US 20 at Shales Parkway Phase I Engineering Study

*Community Advisory Group #3
April 25, 2023*

Feasibility Study – US 20 w/IL 390 Extension (2017)

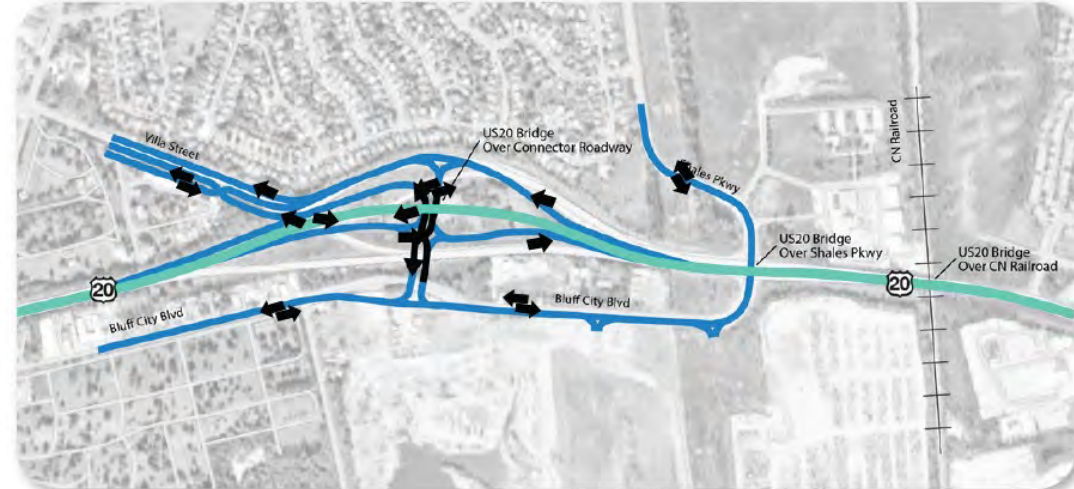
Public comments **did not support** this interchange alternative because of the following:

- Complexity
- Higher impacts to Summerhill Park
- Potential Cost

Diverging Diamond Interchange (DDI)

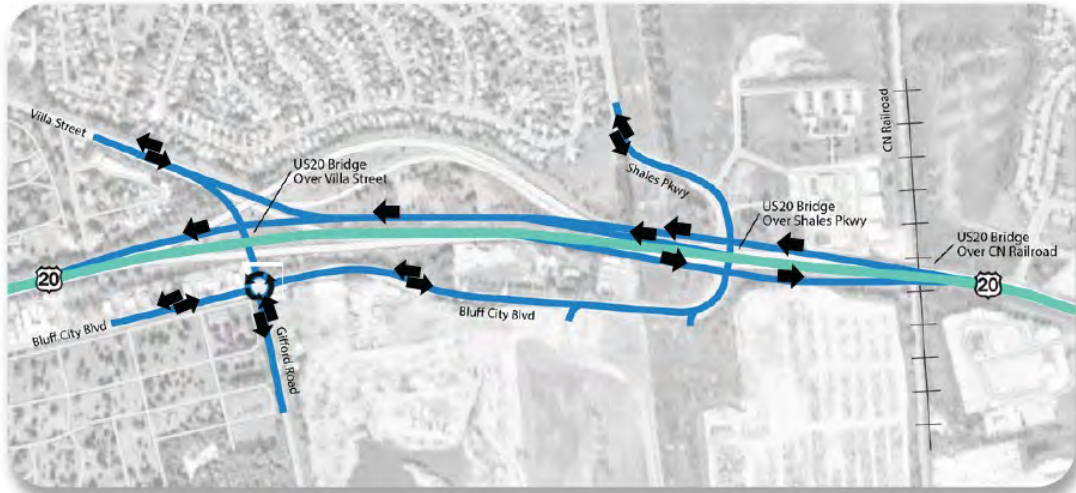
Public comments supported the SPUI and Roundabout options over the DDI interchange alternative because of the following:

- Complexity
- Reduced open space potential
- Increased number of potential intersections

Single Point Urban Interchange (SPUI)

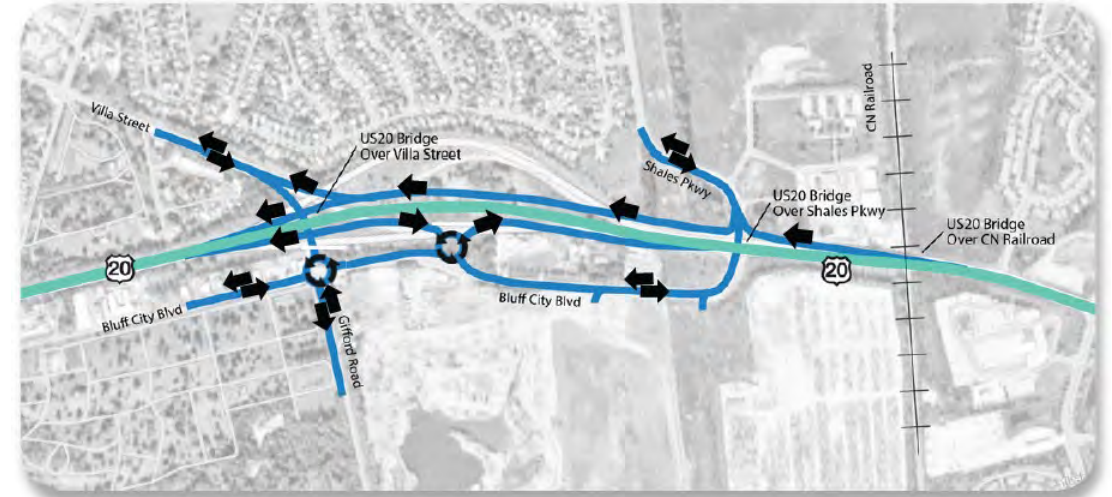
Public comments were **in support** of this interchange alternative because of the following:

- Limited number of intersections
- Additional roadway medians/barriers
- Minimal impact to Summerhill Park
